**TOWN OF NEWBURGH
PLANNING BOARD
TECHNICAL REVIEW COMMENTS**

PROJECT: MALMARK
PROJECT NO.: 20-15
PROJECT LOCATION: SECTION 9, BLOCK 3, LOT 2
REVIEW DATE: 30 APRIL 2021
MEETING DATE: 6 MAY 2021
PROJECT REPRESENTATIVE: MECURIO-NORTON- TAROLLI-MARSHALL

Re: Job No. 3807-3
Tax Map Parcel: 9-3-2
Town of Newburgh
Orange County
Lattintown Road
5-lot Residential Subdivision

Survey Map & Subdivision Plan
 for
Malmark Construction Corp.

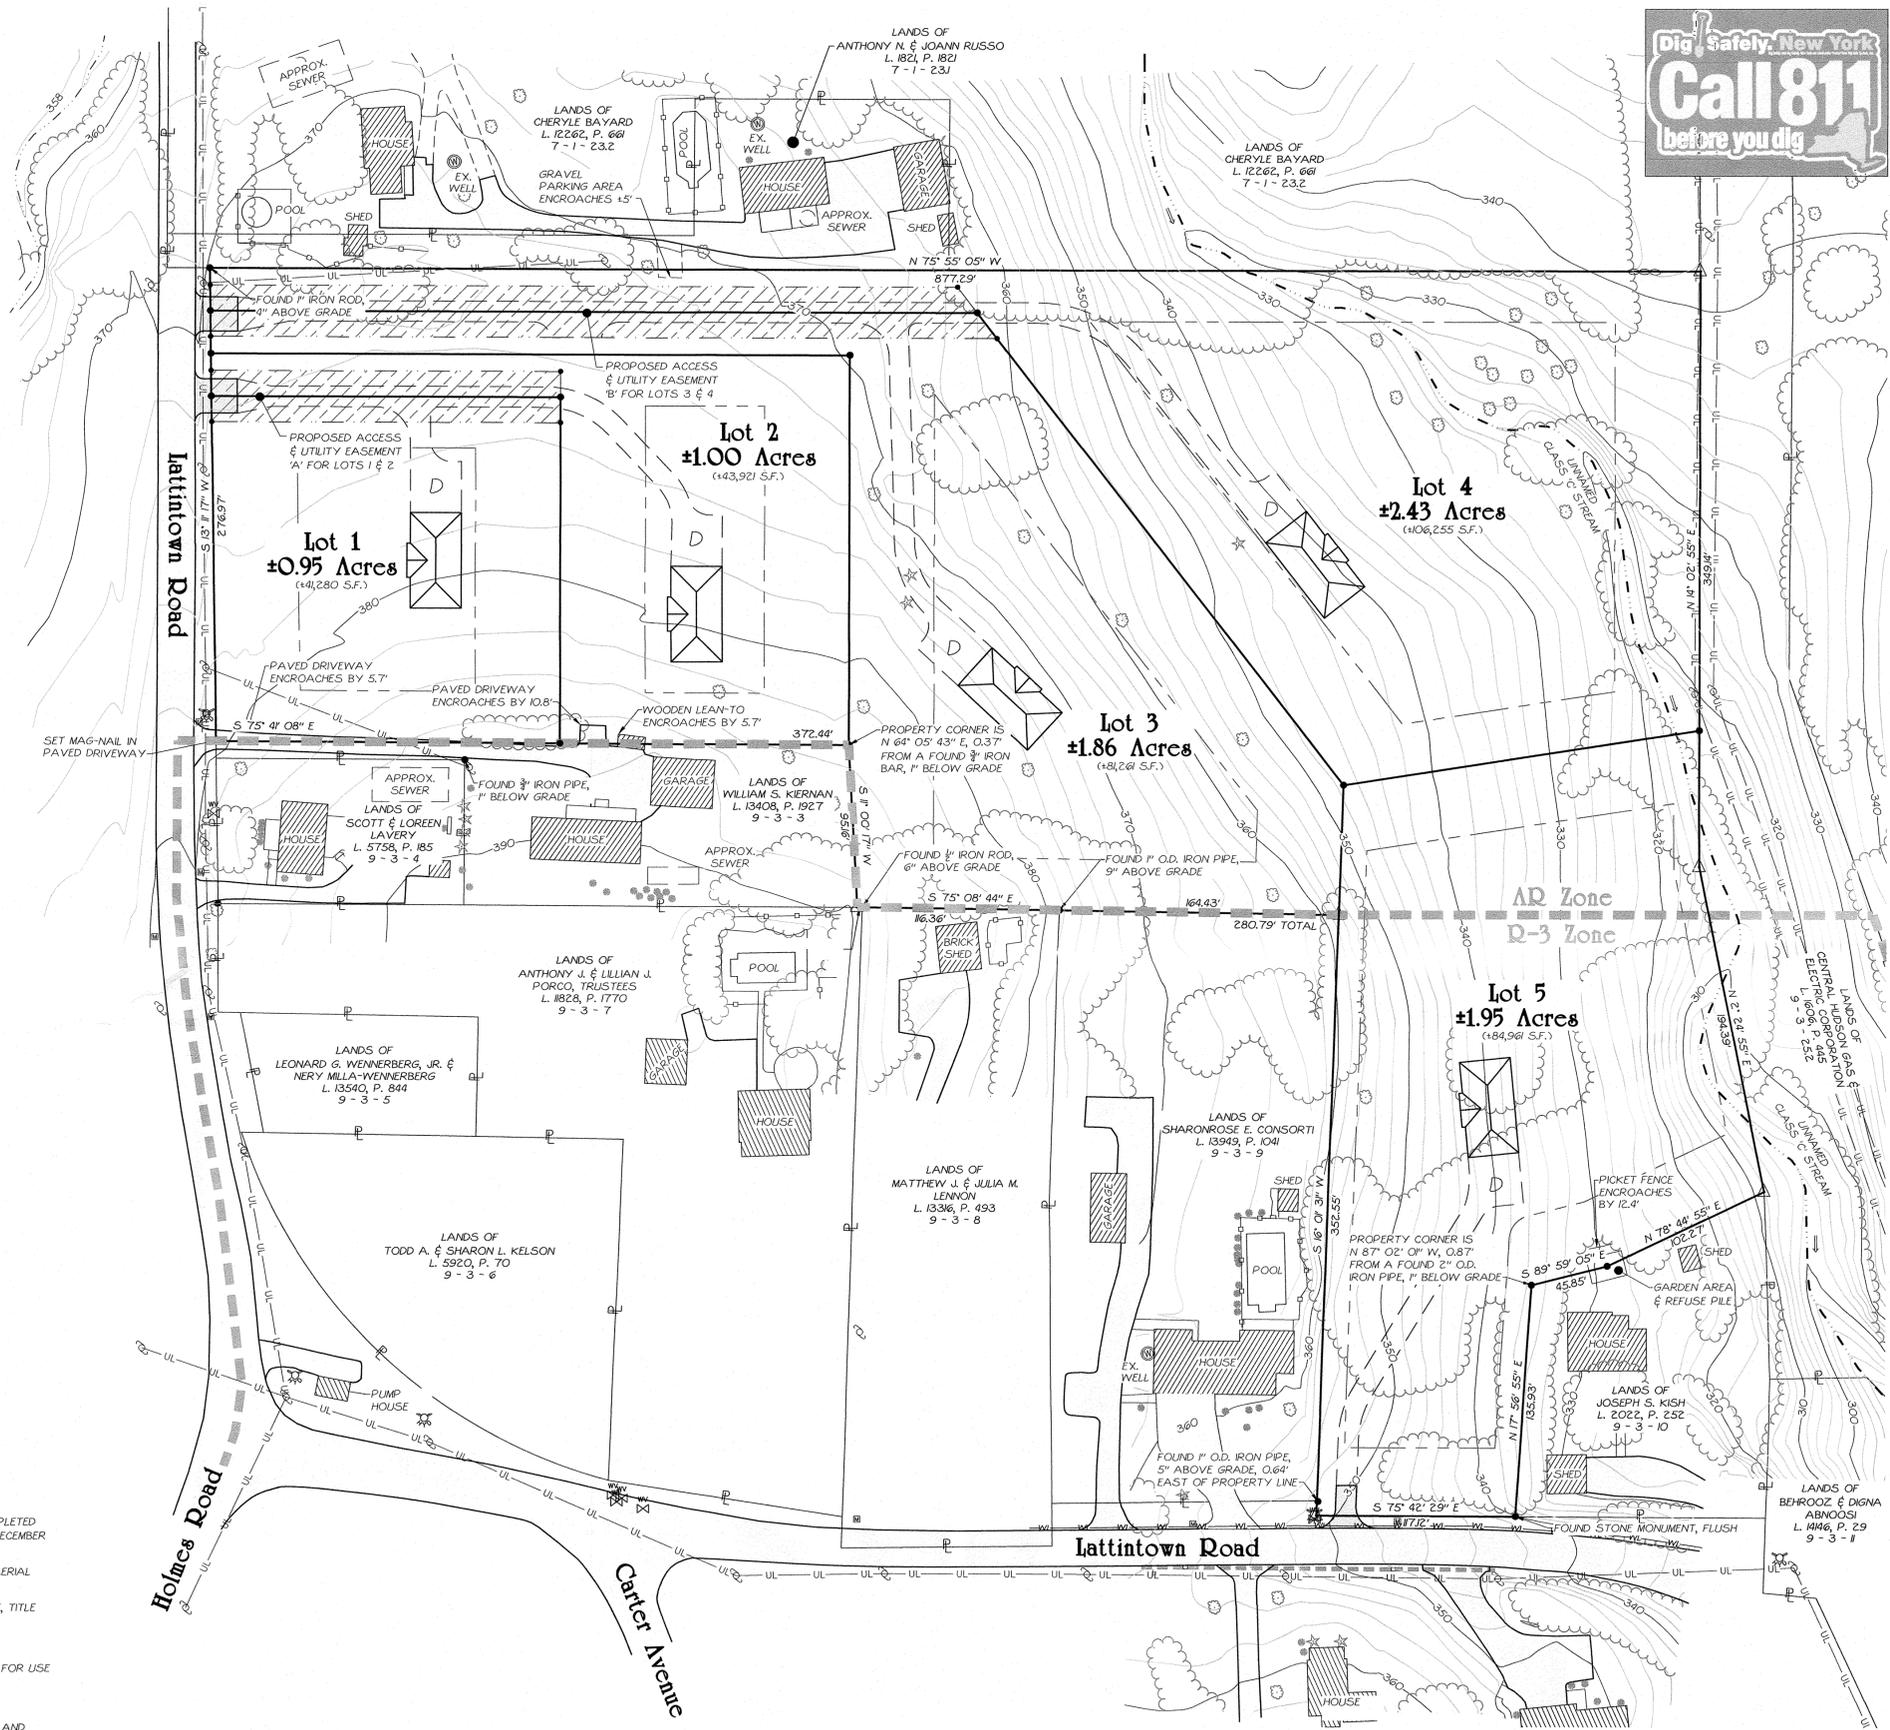
1. Copy of the Highway Superintendents sign off letter for the access points should be submitted for the Planning Boards use.
2. Several comments continue to be outstanding from the 29 January 2021 including addressing encroachments onto proposed Lot 2. Internal subdivision lot line metes and boundaries should be added to the plans. Driveway access and maintenance agreement should be submitted to Dominic Cordisco for review. These access agreements should include cross grading easements.

3. Metes & bounds will be included on the proposed property lines for future submissions.
4. No response required.
5. Reference to the proposed access easements for the common driveways is included in notes 8 and 9 on sheet 1. The easements will include provisions for installation and maintenance of the proposed driveways and utilities serving the individual lots.

9. No response required.
10. Note 1 has been added under the Zoning Legend on sheet 1 specifying lot specific bulk zoning information is provided on sheet 3. Note 10 has also been added on sheet 1 to this effect.
